September 4, 1987

Subject: Dresden Station Unit 2
"Continued Operation Criteria for LPCI Piping"
NRC Docket No. 50-237

FIGURE 1

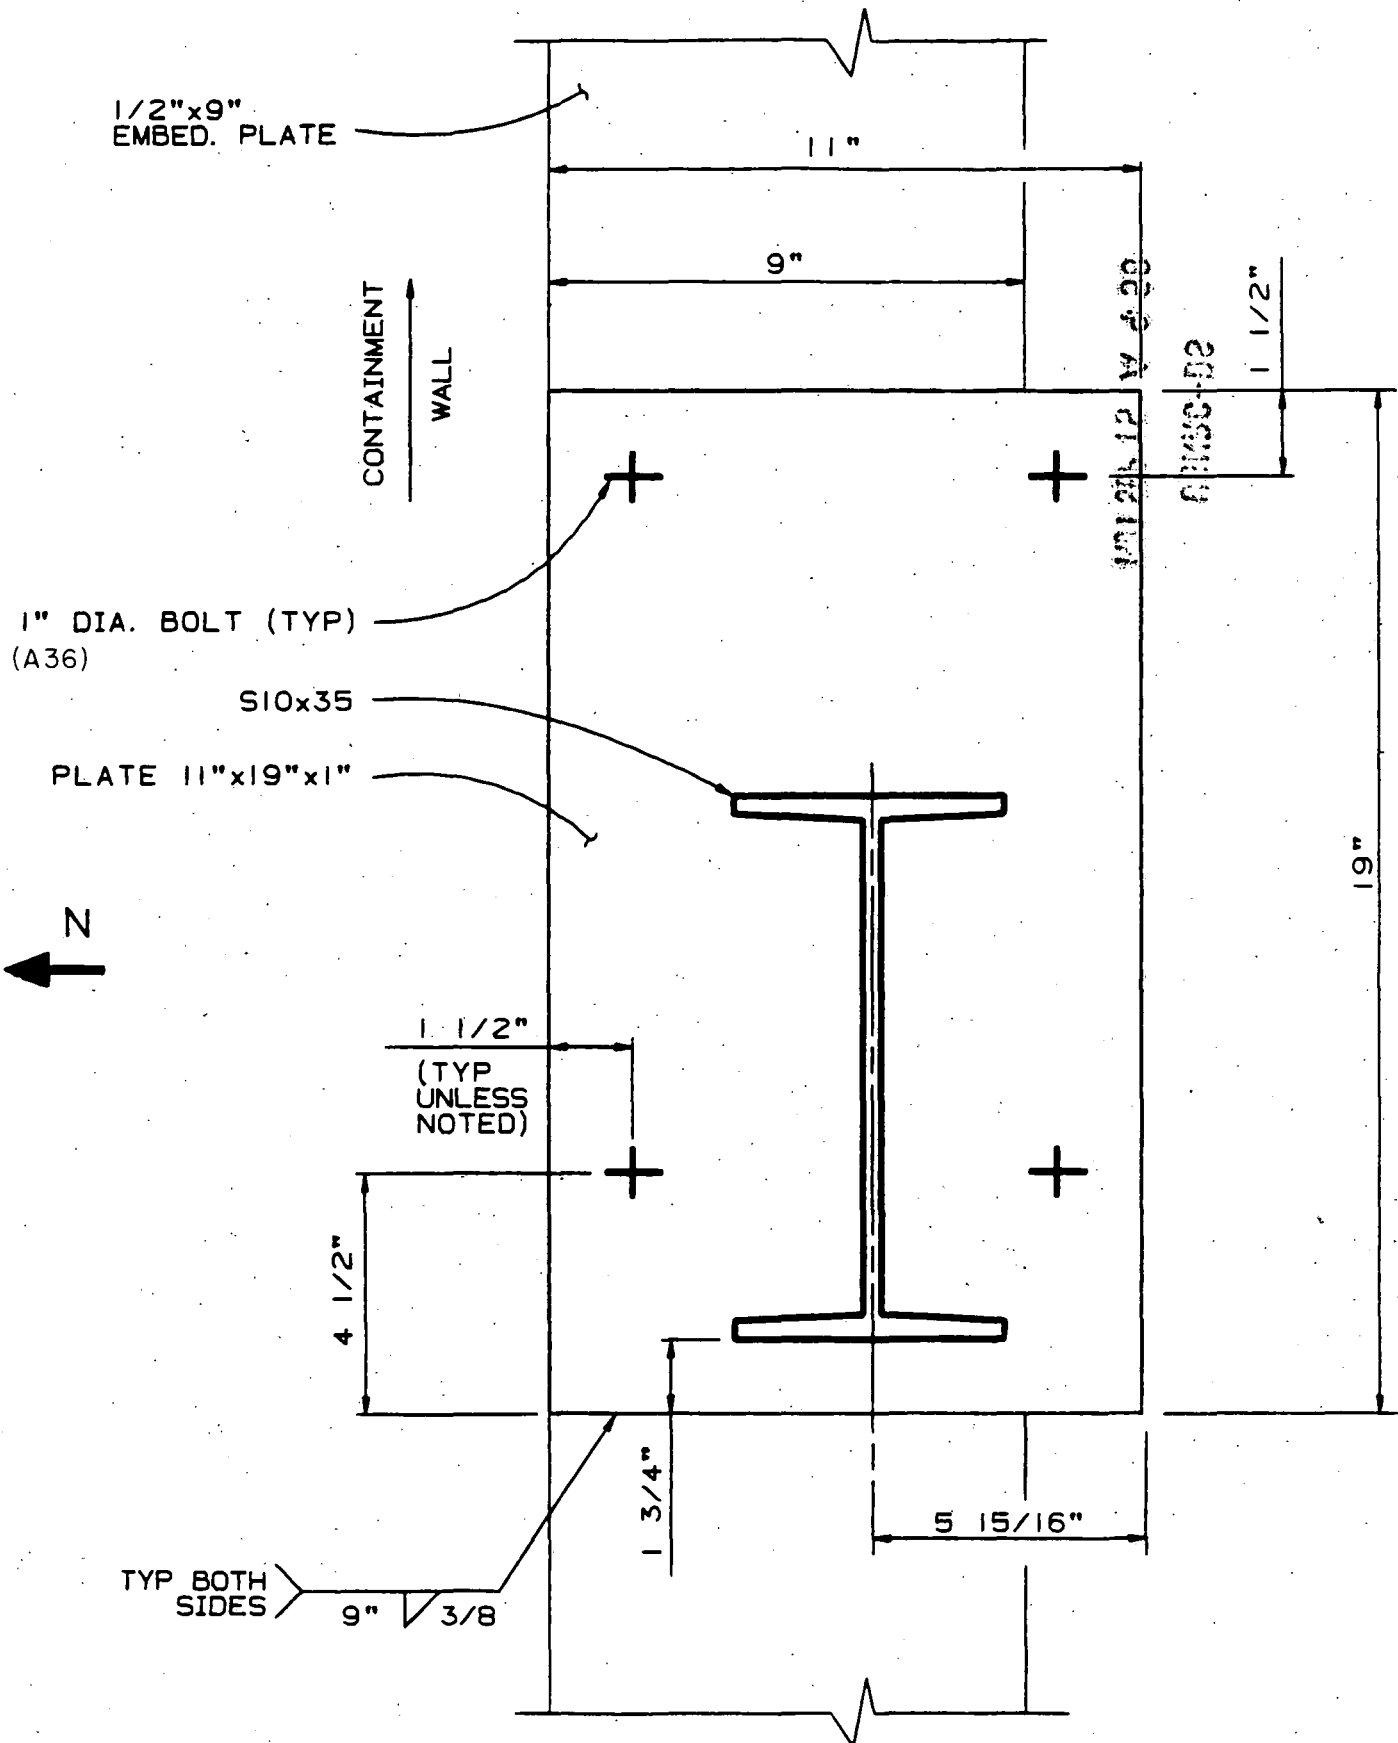
In conjunction with the Dresden Unit 2 embedment strip plate evaluation, a support configuration on the LPCI System was identified which exceeded design basis requirements. The support configuration is shown in Figure 1. Further evaluation showed that a minor modification to the system would satisfy design basis requirements. The specific changes needed are: (1) larger diameter anchor bolts, and (2) a thicker baseplate.

Figure 1 shows the current configuration of the LPCI support. This support is attached to the reactor building floor by anchor bolts and by a weldment between the baseplate and strip plates embedded in the same floor. Using design basis loads and methods, both the baseplate and the anchor bolts exceed the design basis. We propose to use the allowable ductilities in ANSI/AISC N690-84 to qualify the existing baseplate and anchor bolts for continued operation. A minor design modification will be installed during the next refueling outage, such that the support will conform to design basis requirements.

Based on the results of our preliminary analyses, using Regulatory Guide 1.61 values and ANSI N-690 guidance, Commonwealth Edison believes the LPCI system supports configuration is operable. This preliminary analysis provides the basis for our assurance that Dresden 2 may continue to be operated. We commit to modify this support and restore it to meet the FSAR in our upcoming September 1988 refueling outage.
